City of Detroit  
Inter-Departmental Communication

**RE:** Petition No. 530  
Requested Encroachment into Randolph at 1407 Randolph with Outdoor Seating

**NOTICE OF PROPOSED CHANGE IN PROPERTY**

**REQUEST ENCROACHMENT  
 INTO RANDOLPH  
 AT 1407 RANDOLPH  
 (With Outdoor Seating)**

CITY OF DETROIT

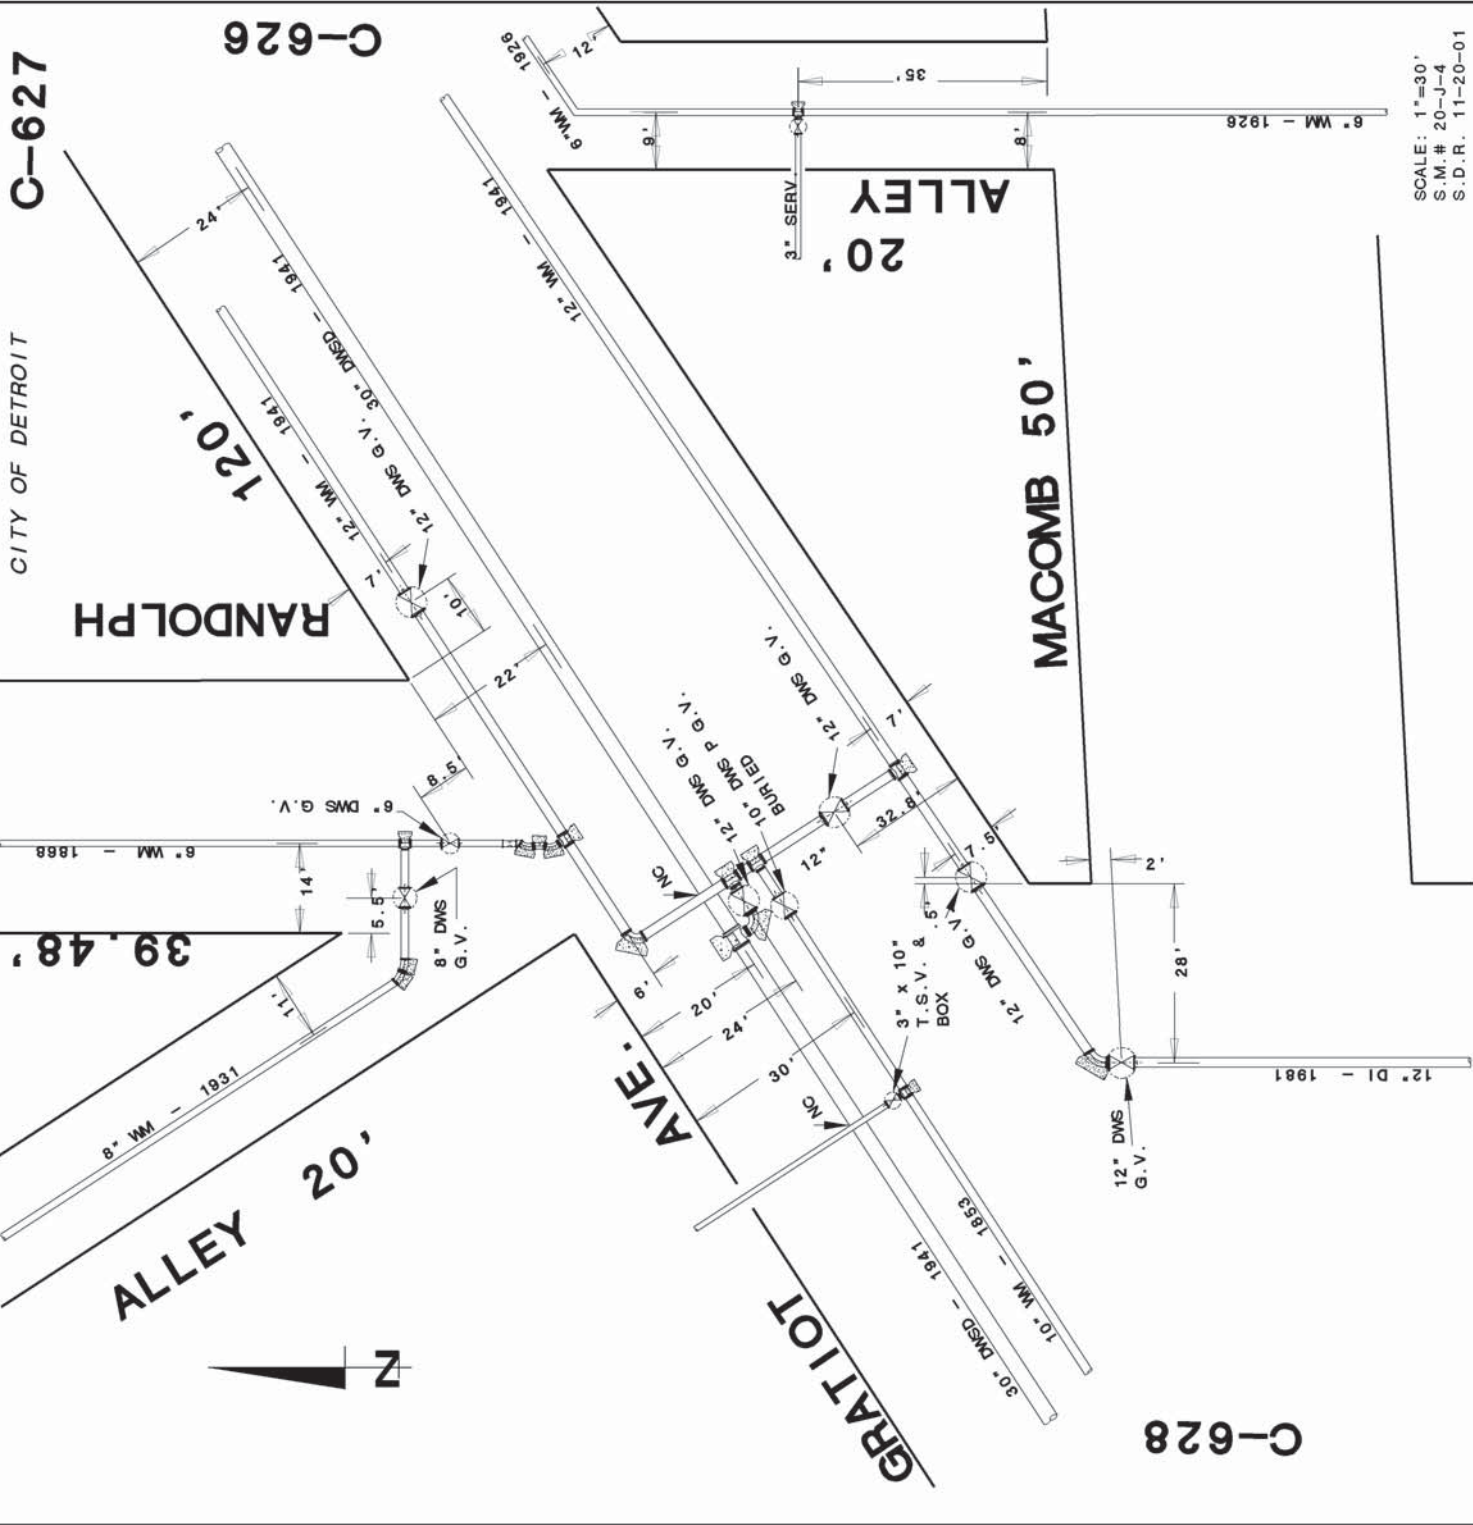
- Our records indicate that there are water mains and sewers in the areas of encroachments. DWSD has no objections to the requested encroachment provided that the attached Provisions for Encroachment are strictly followed.

Detroit Water and Sewerage (DWSD) agree to the proposed encroachment subject to the fulfilling of the following provisions:

1. By approval of this petition the (DWSD) does not waive any of its rights to its facilities located in the right of way, and at all time, DWSD, its agents or employees, shall have the right to enter upon the right of way to maintain, repair, alter, service, inspect, or install its facilities. All costs incident to the damaging, dismantling, demolishing, removal and replacement of structures or other improvements herein permitted and incurred in gaining access to DWSD's facilities for maintenance, repairing, alteration, servicing or inspection caused by the encroachment shall be borne by the petitioner. All costs associated with gaining access to DWSD's facilities, which could normally be expected had the petitioner not encroached into the right of way shall be borne by DWSD.

2. All construction performed under this petition shall not be commenced until after five (5) days written notice to DWSD. Seventy-two (72) hours notice shall also be provided in accordance with P.A. 53 1974, as amended, utilizing the MISS DIG one call system.

3. Construction under this petition is subject to inspection and approval by DWSD forces. The cost of such inspection shall, at the discretion of DWSD, be borne by the petitioner.

4. If DWSD facilities located within the right of way shall break or be damaged as the result of any action on the part of the petitioner, then in such event the petitioner agrees to be liable for all costs incident to the repair, replacement or relocation of such broken or damaged DWSD facilities.

5. The petitioner shall hold DWSD harmless for any damage to the encroaching device constructed or installed under this petition, which may be caused by the failure of DWSD's facilities.
